Approved Section 75W Modification Application

No. MP 10-0027 MOD1 granted on the 24 JULY 2012

Revision E - Section 75W Amendments

Site 3
Sydney Olympic Park
Plan
Basement 001

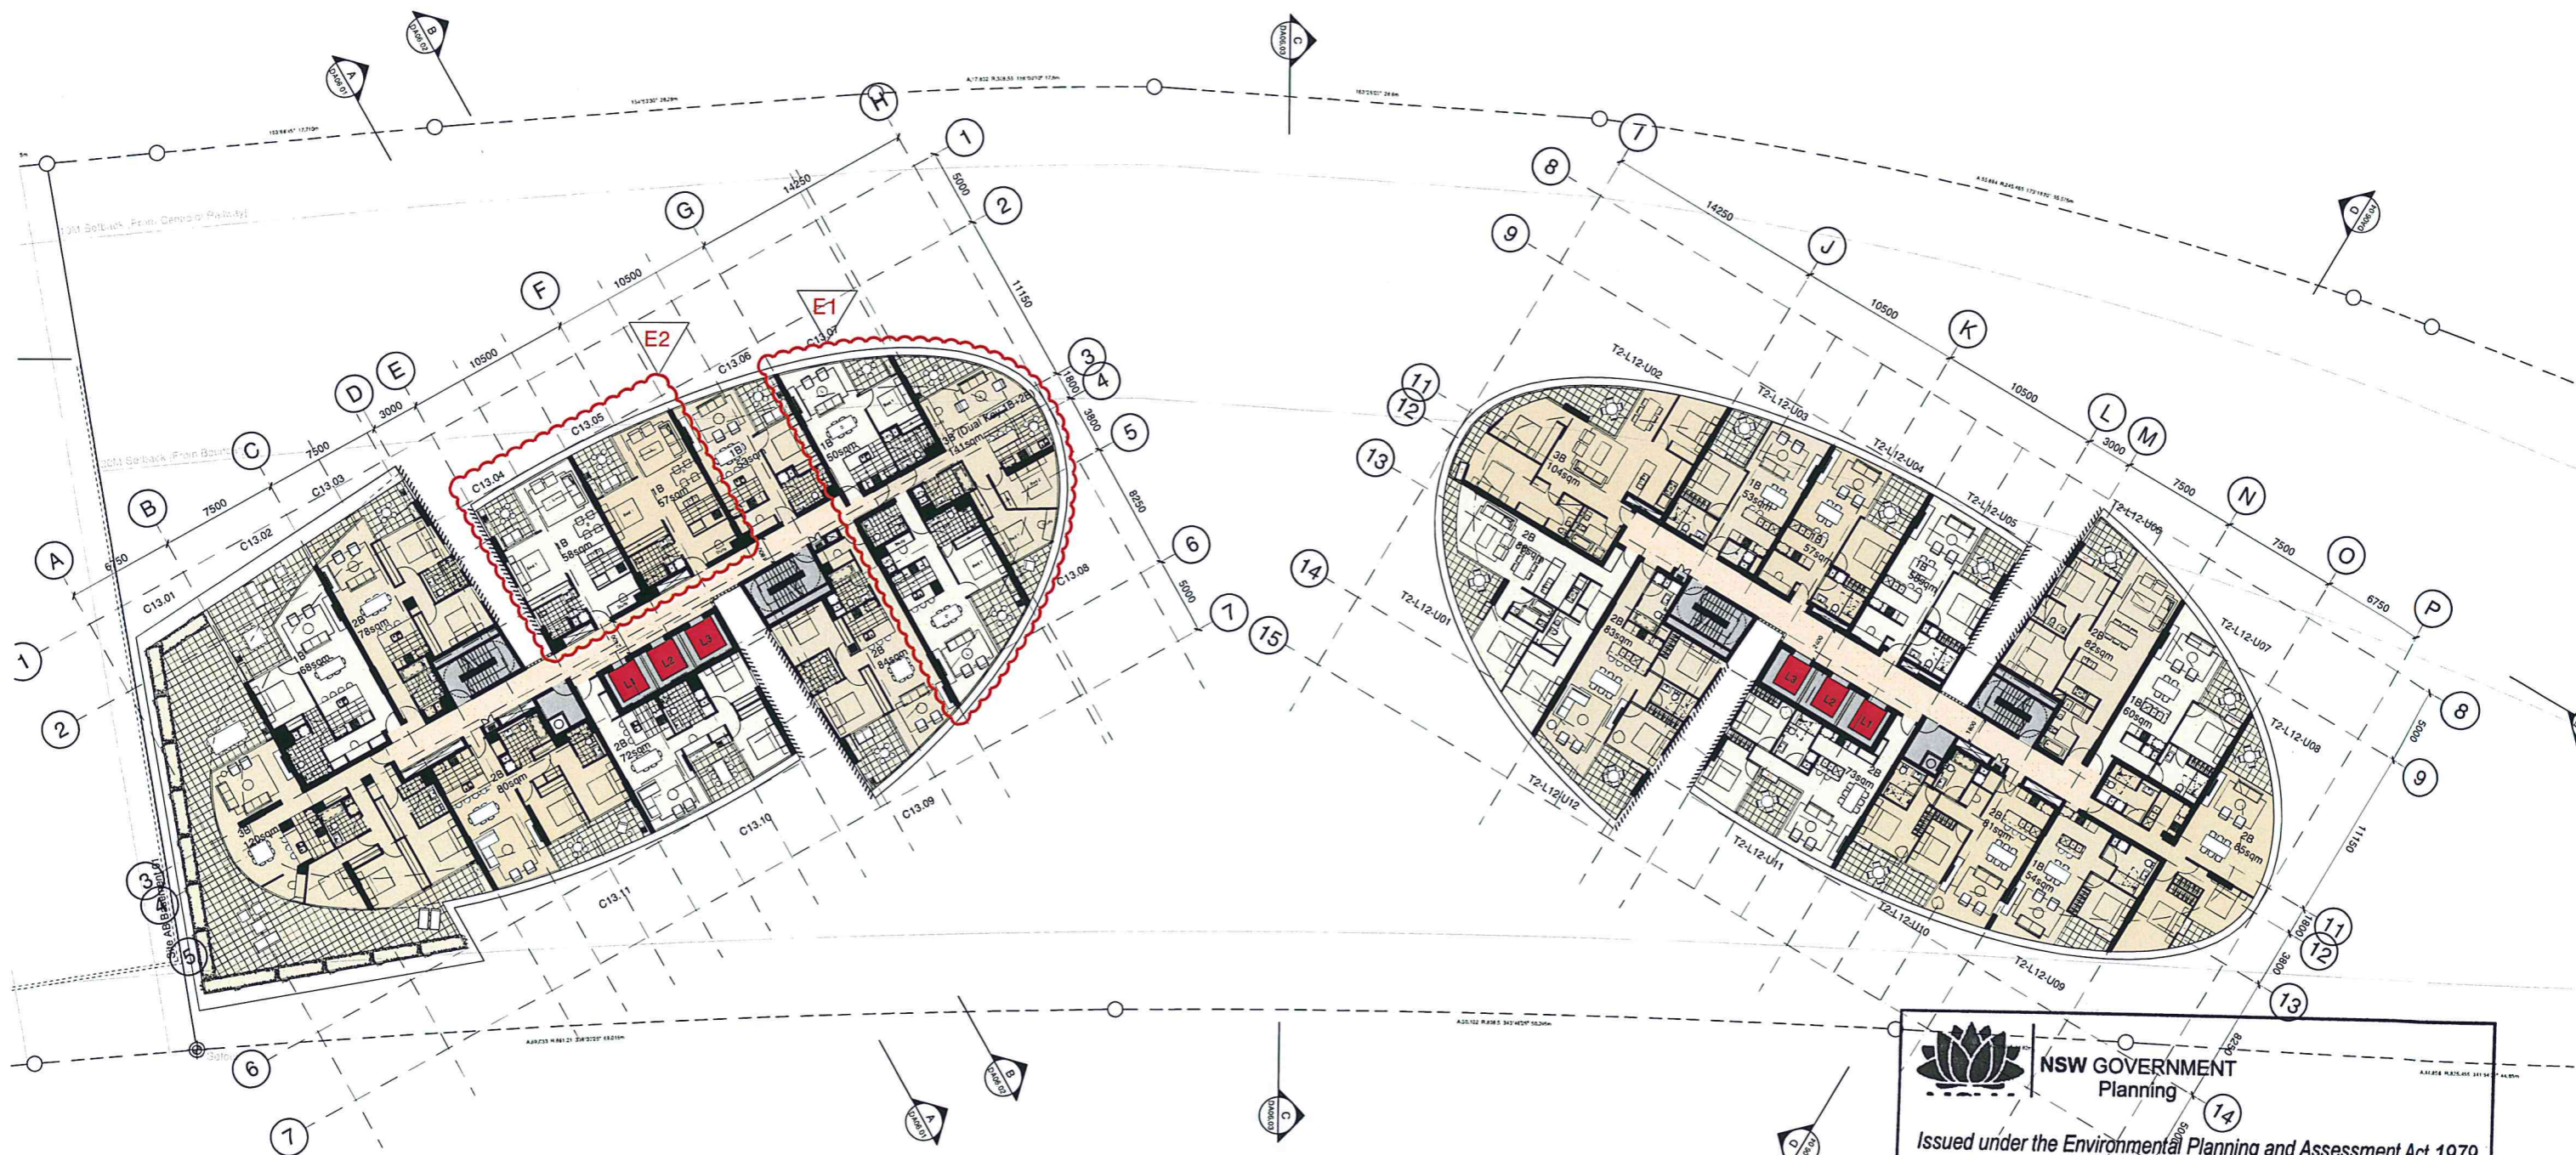
1 Four scooters have been converted to two disabled spaces to accommodate increase in total accessible apartments numbers (additional 2, from 55 to 61)

Site 3
 Sydney Olympic Park
 Plan
 Level 12

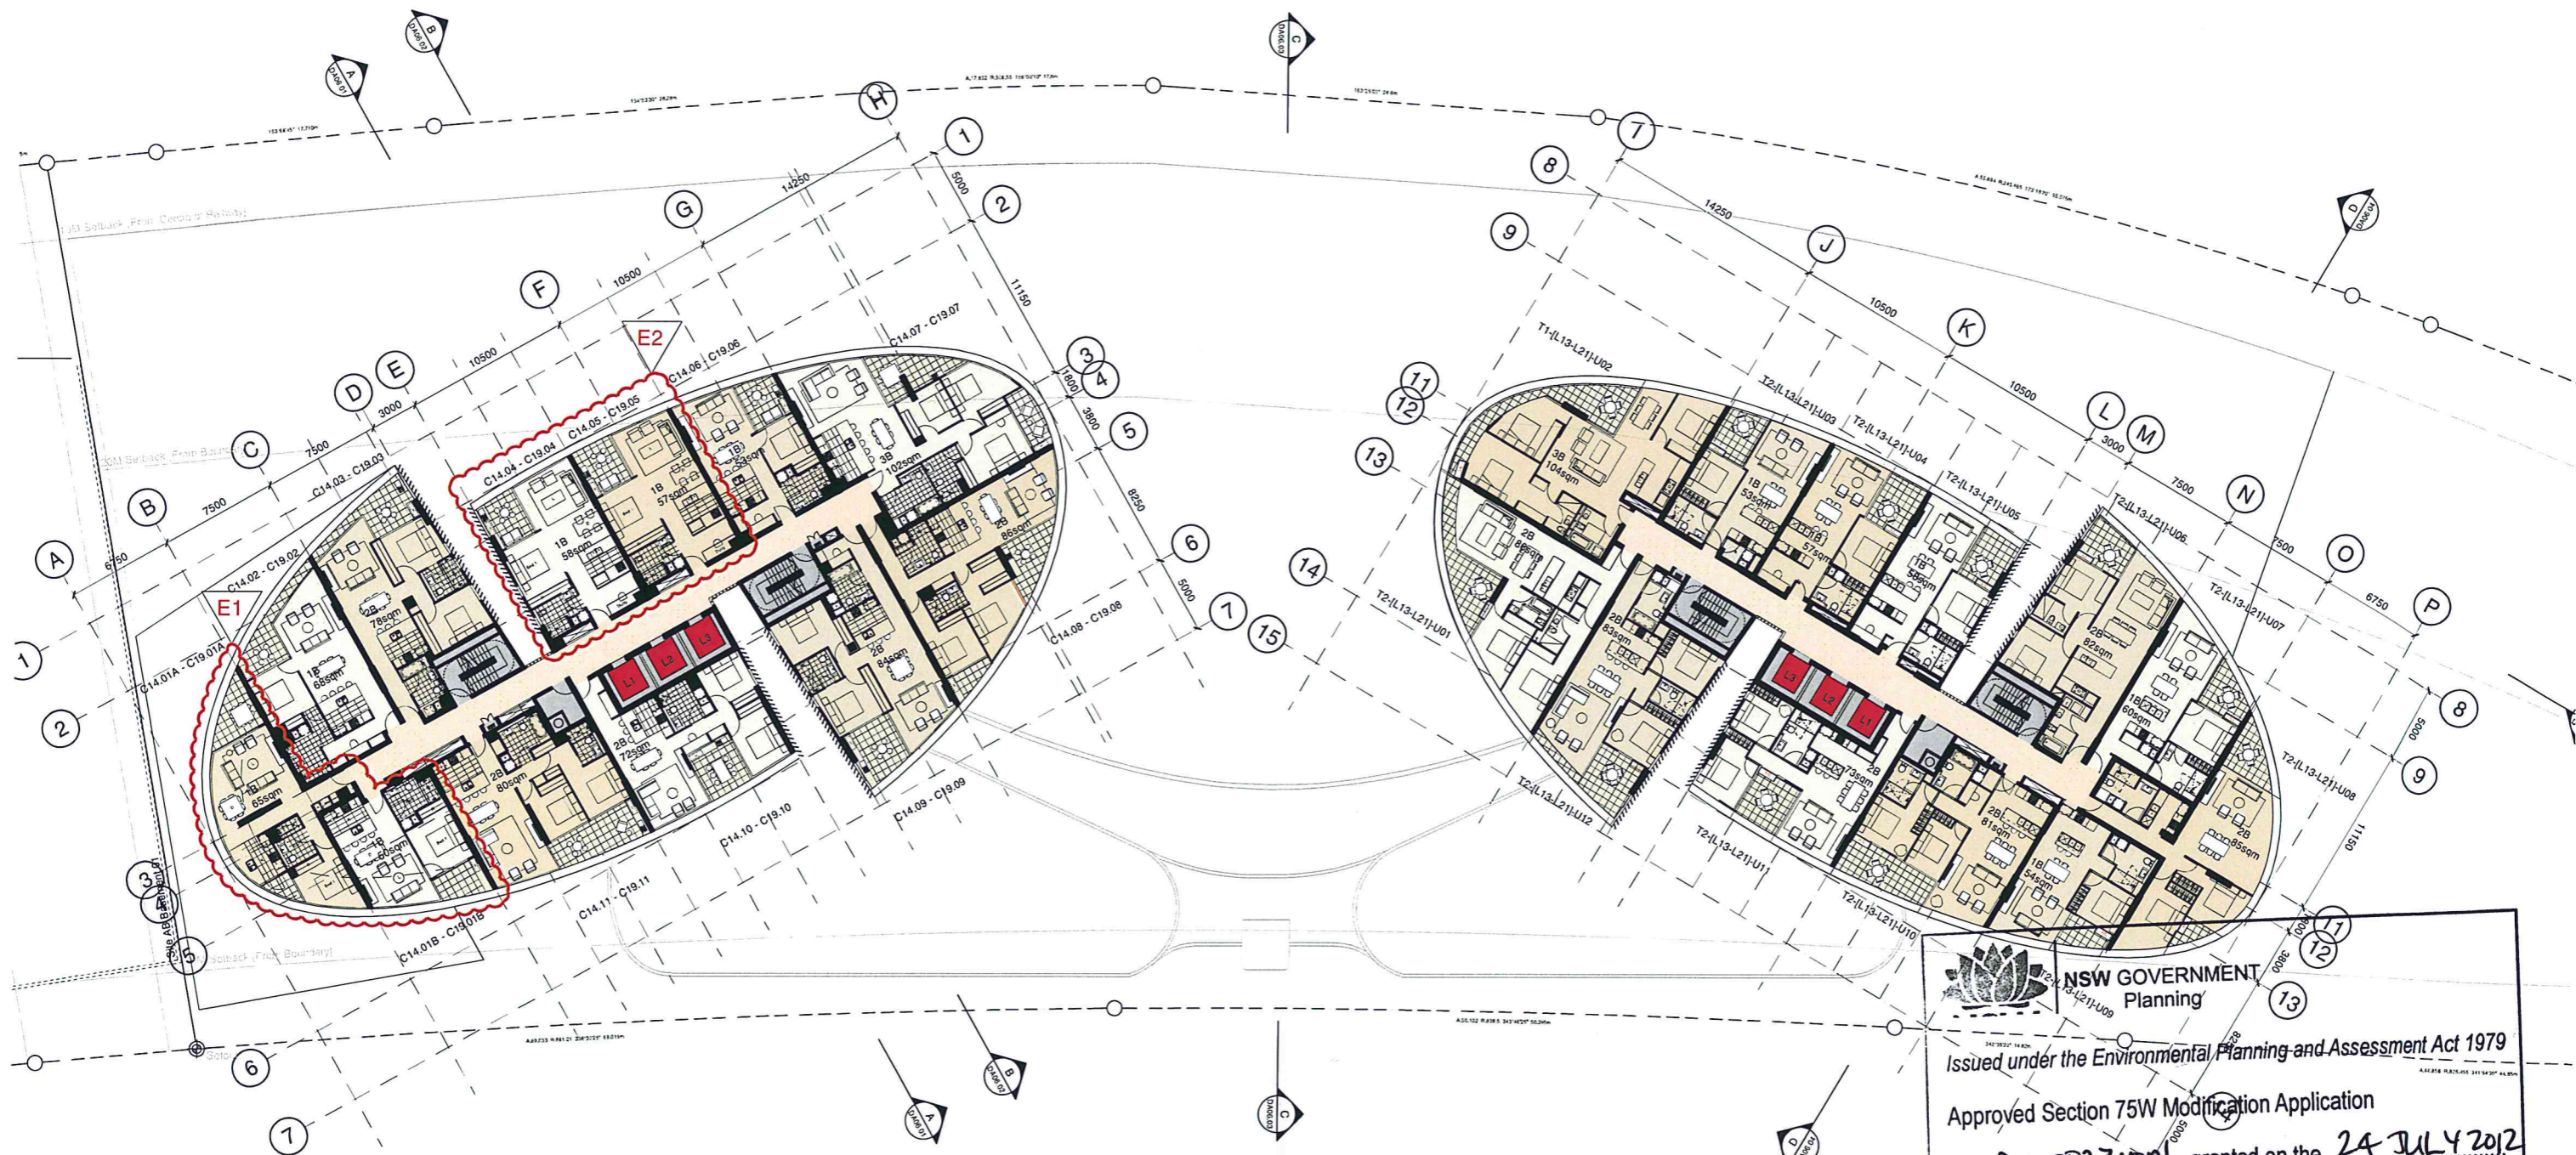
1. Change of apartment mix from one 3-Bed and one 2-Bed (C13.07 & C13.08) to one 1-Bed and one 3-Bed Dual Key (1-Bed+2-Bed) (C13.07 & C13.08).
2. Apartments C13.04 & C13.05 have been allocated as admissible units.

Site 3
Sydney Olympic Park
Plan
Level 13-18

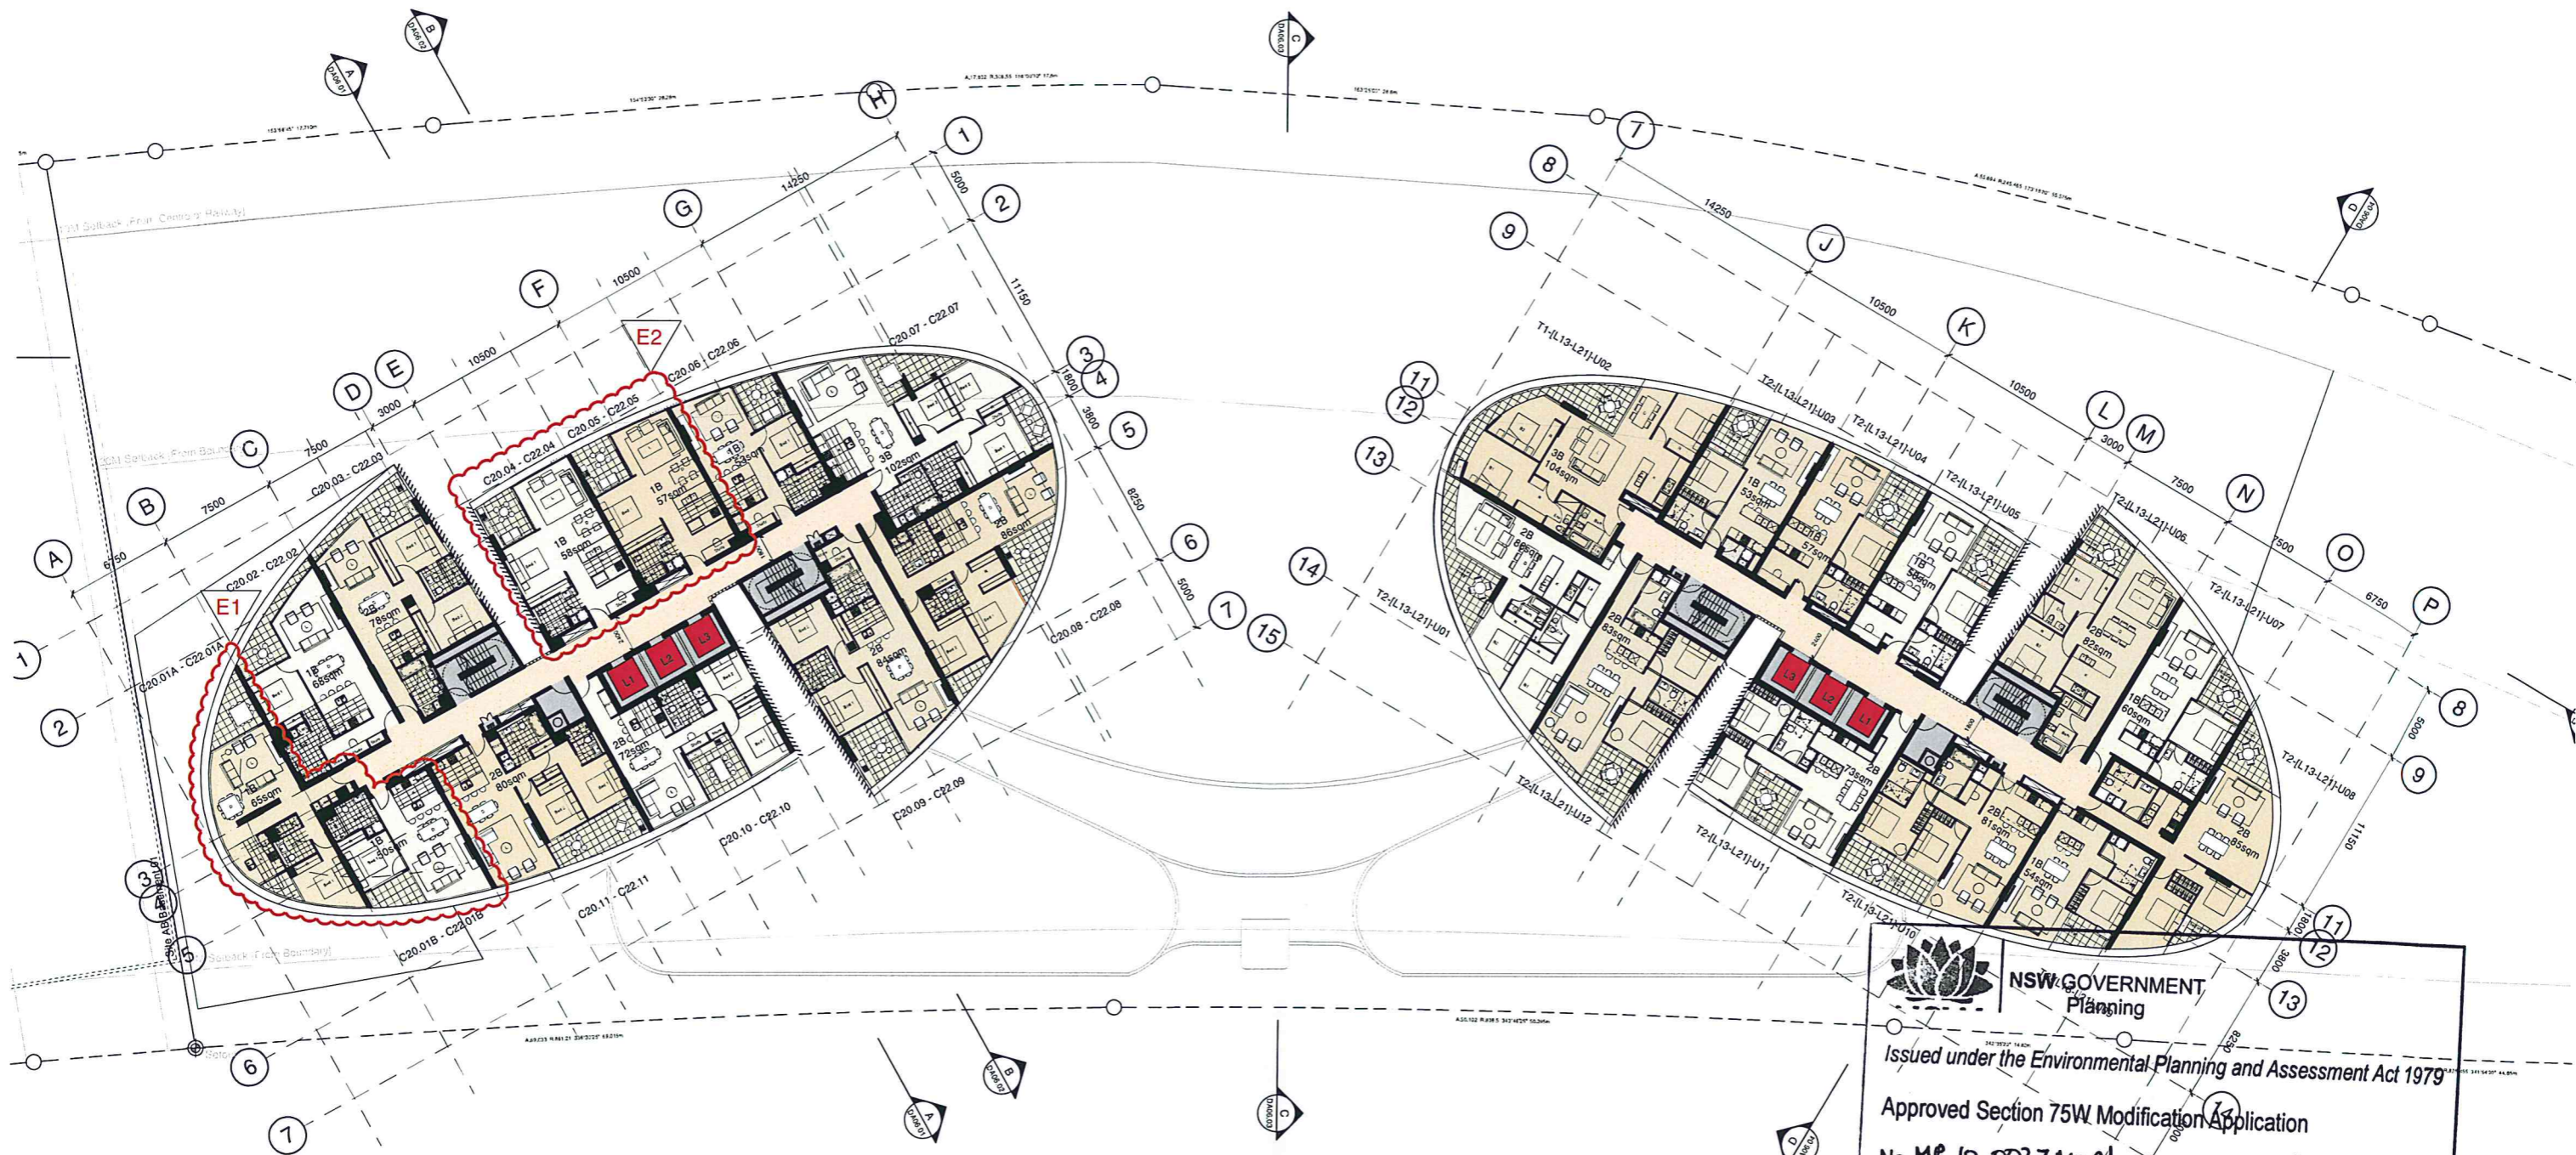
Revision E - Section 75W Amendments
 1. Change of apartment mix from one 3-Bed (C14.01-C22.01) to two 1-Bed (C14.01A-C22.01A & C14.01B-C22.01B).
 2. Apartments C14.04-C22.04 & C14.05-C22.05 have been allocated as adaptable units.
